# U2004A-03

# S E R V I C E N O T E

## U2004A 9kHz – 6GHz USB Sensor

**Difficulty to attach USB power sensor cable to power sensor unit.**

Figure 1: USB power sensor cable fully attached to power sensor unit

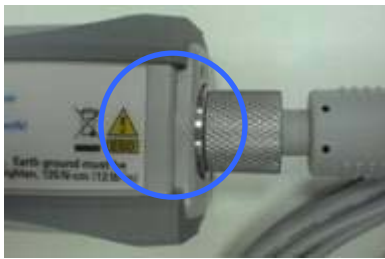
When the USB power sensor cable is attached to the power sensor unit, user may find it difficult to attach the cable to the power sensor unit.

If user faces difficulty to attach the cable to the power sensor unit, kindly contact Agilent for free of charge cable replacement. Kindly scrap the used cable.
